ADDENDUM

Project: Craft State Office Building 1 HVAC
– 200 South Silber Avenue, North
Platte, NE, 69101

Project No.: 23059

Addendum No.: 1

GROUND & FIRST FLOOR
PLAN - ELECTRICAL

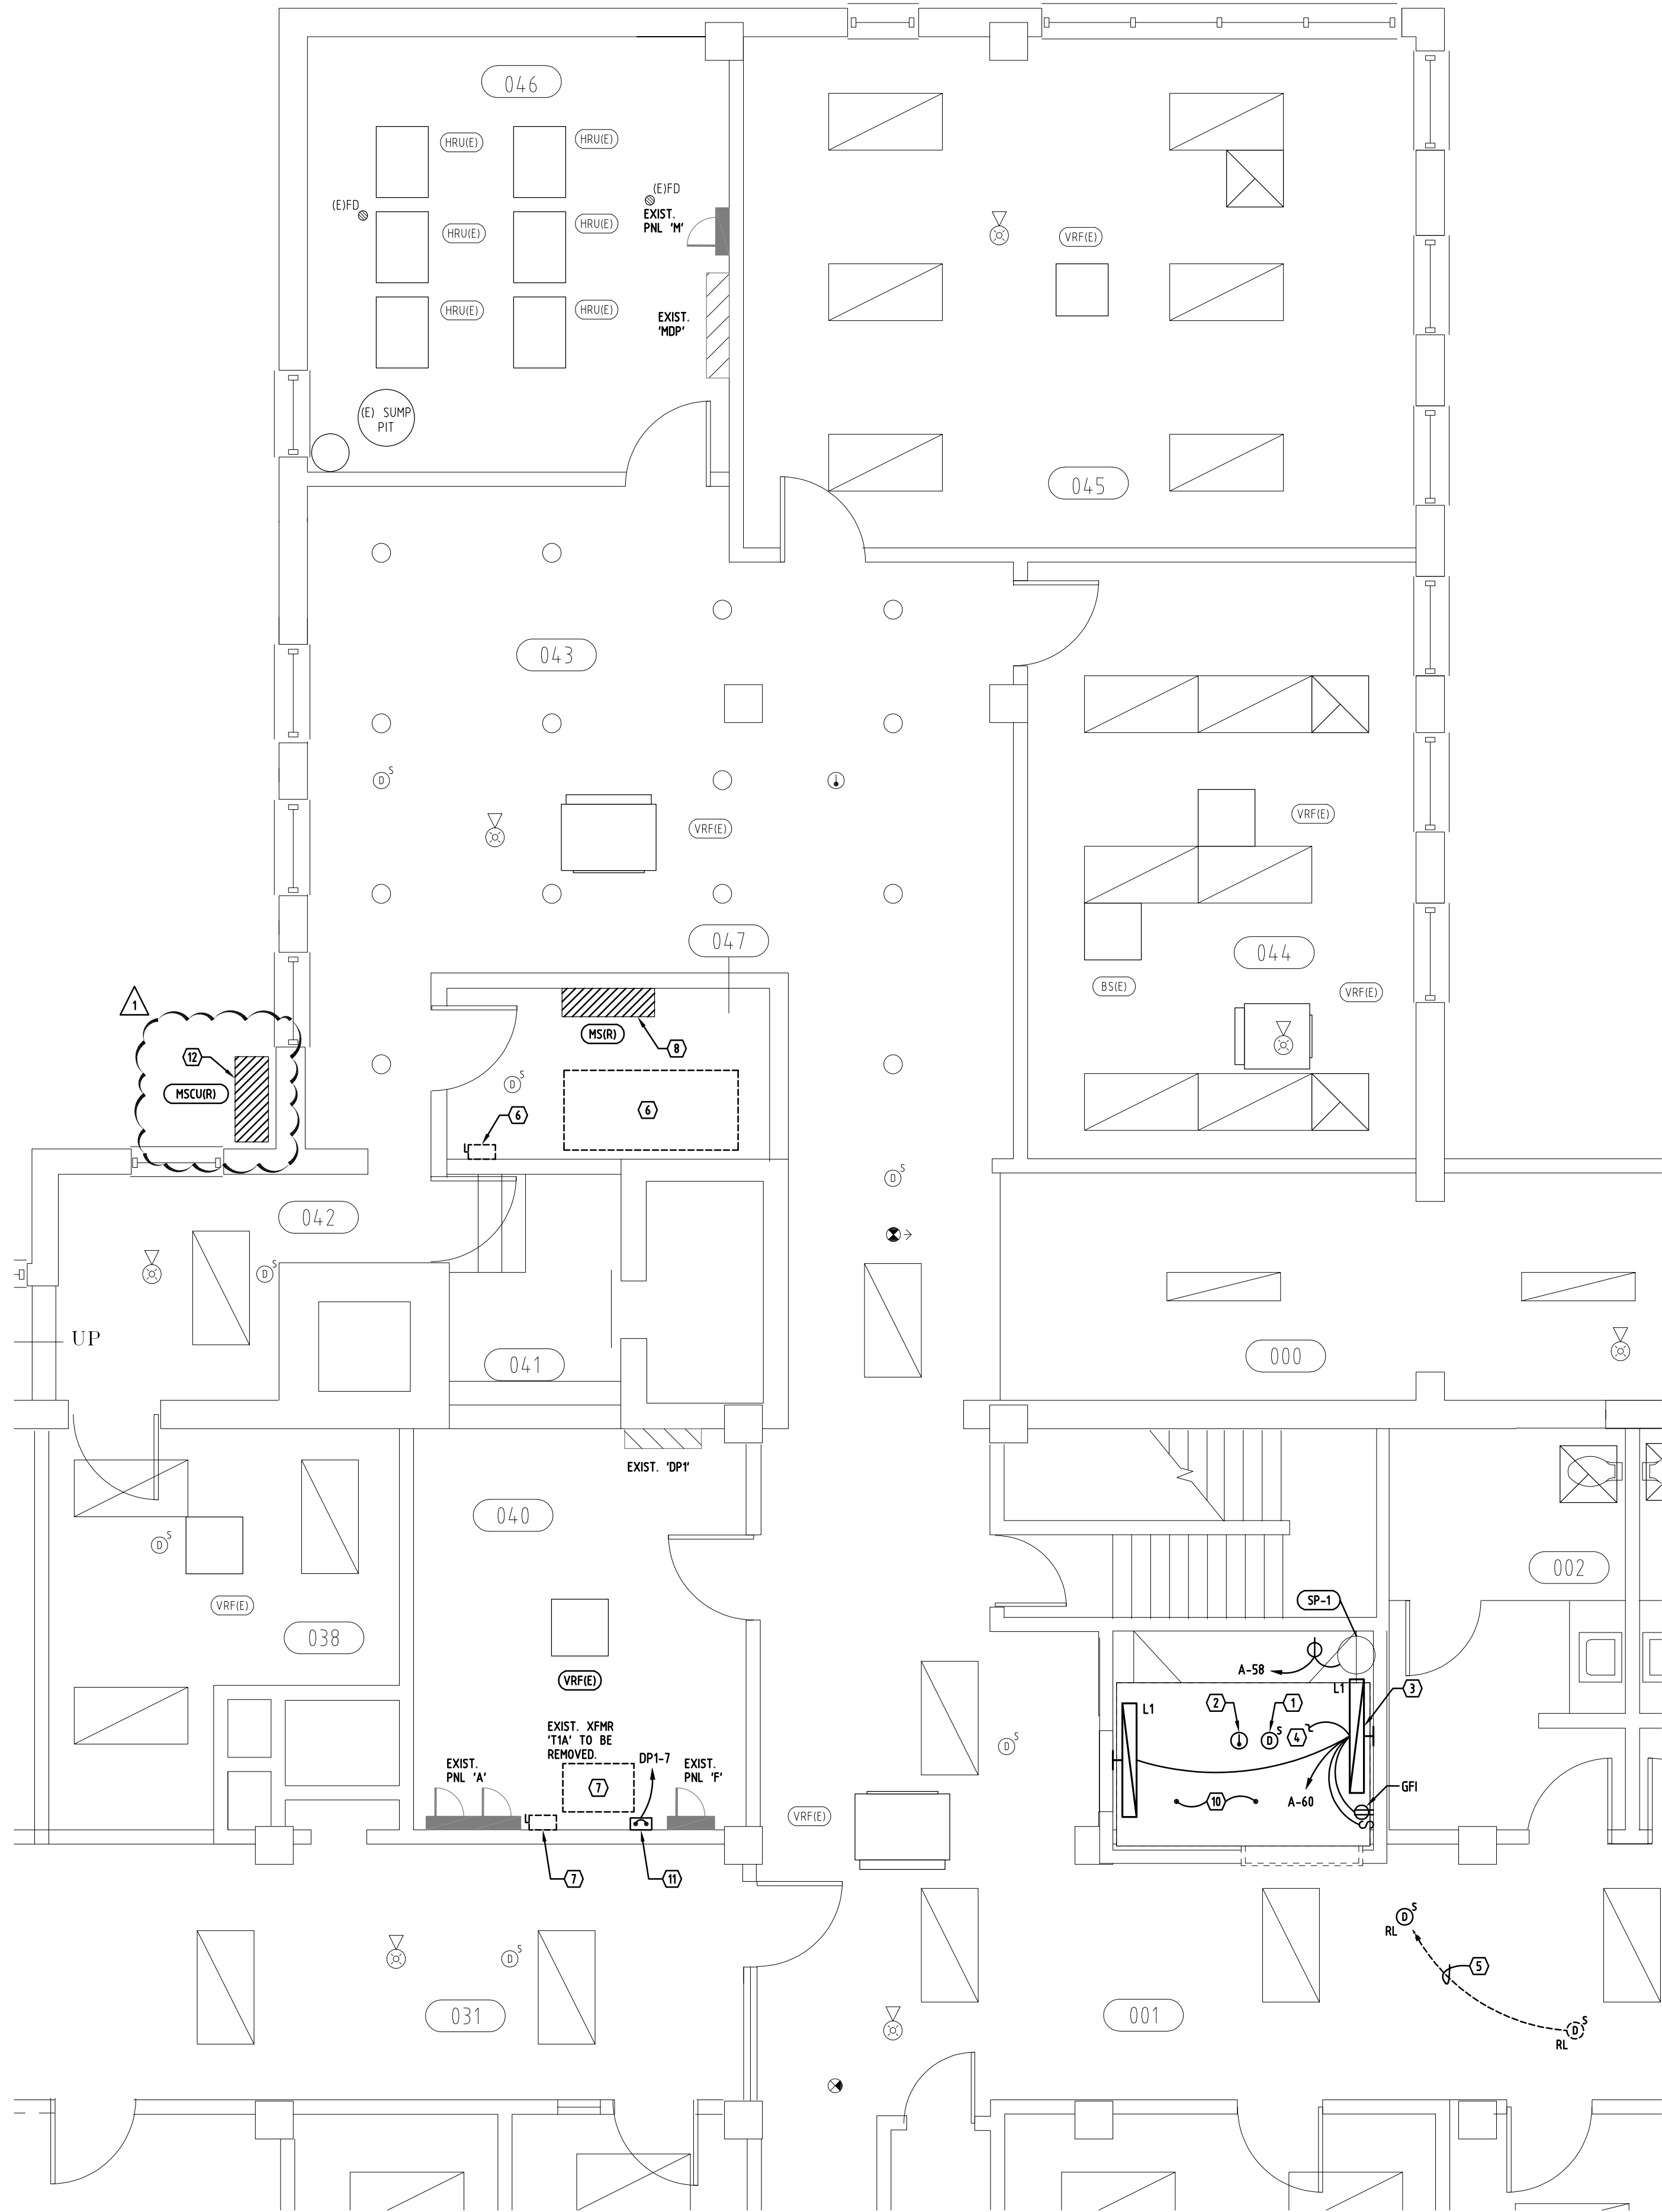
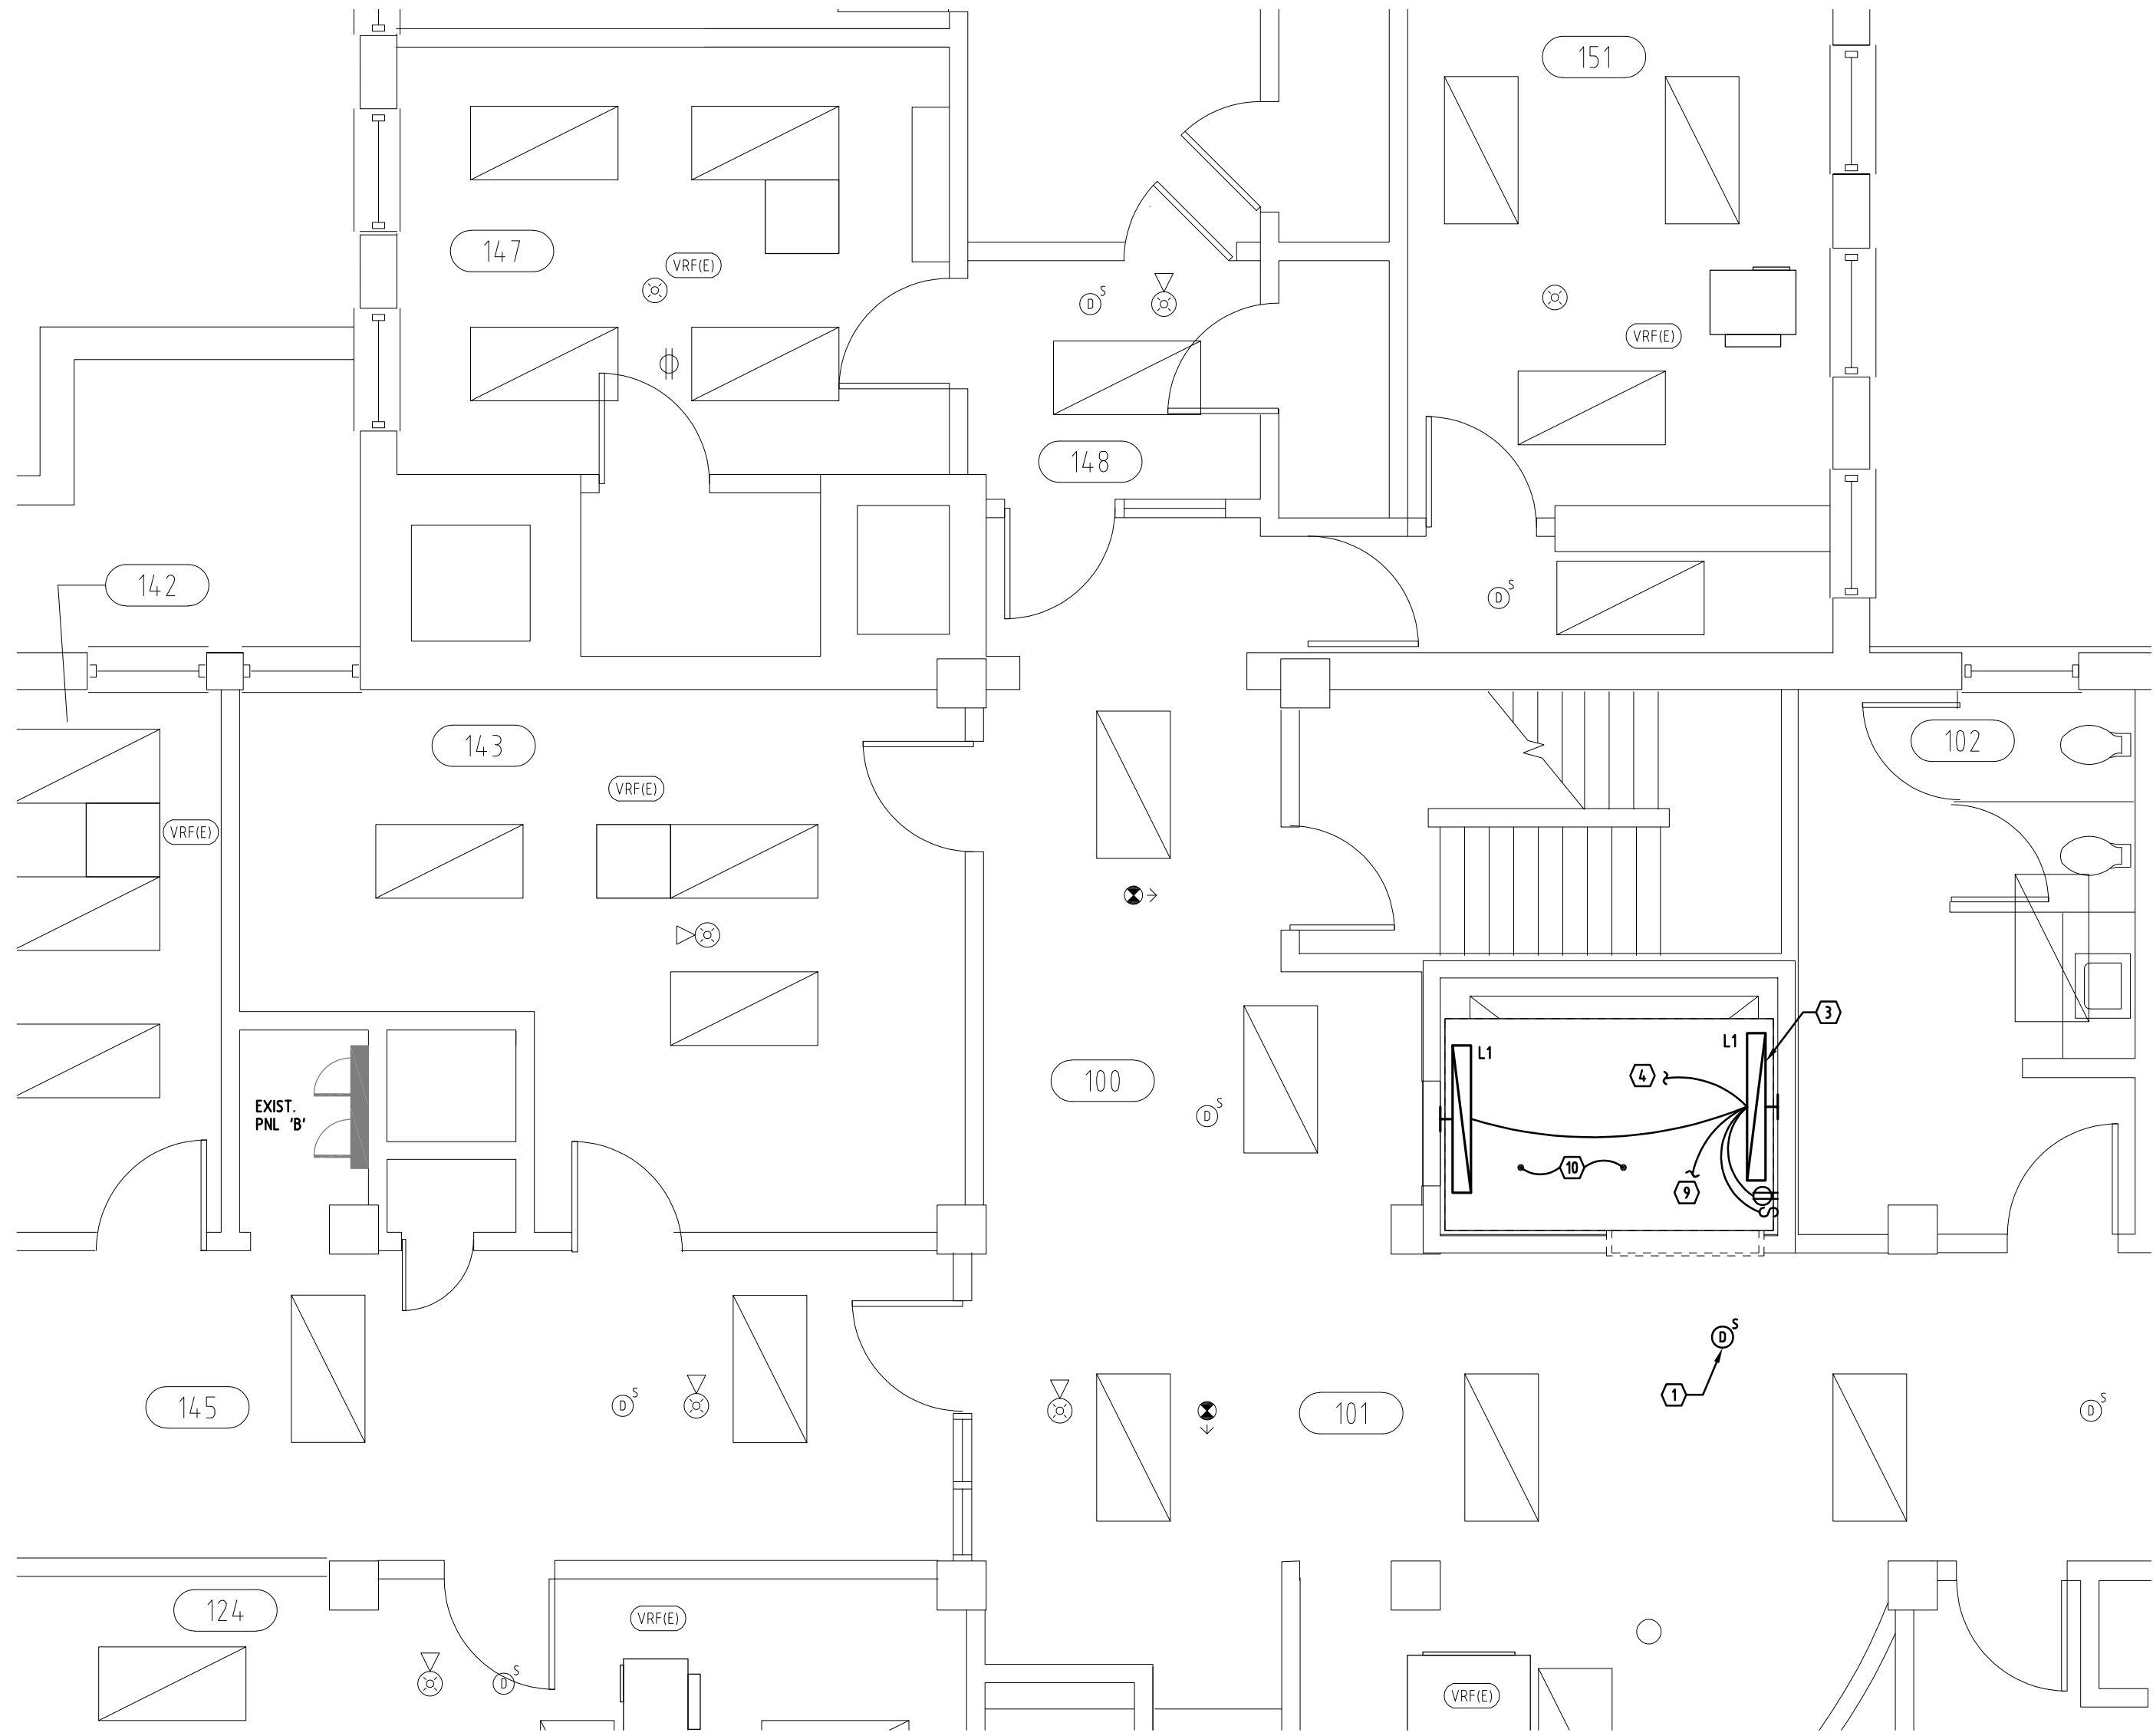
1. **E1.1 – GROUND & FIRST FLOOR PLAN – ELECTRICAL**
 - a. Keynote #12 has been added to specify relocating existing MSCU.
2. **E1.2 – SECOND AND THIRD FLOOR PLAN – ELECTRICAL**
 - a. Keynote #13 has been added to specify the new location of existing MSCU.

12. EXISTING CONDENSING UNIT, DISCONNECT, CONTROLS, AND RECEPTACLE TO BE RELOCATED TO ROOF. CONTRACTOR TO FIELD VERIFY EXISTING BREAKER AND CONDUIT/WIRE SIZE. COORDINATE WITH MECHANICAL CONTRACTOR.
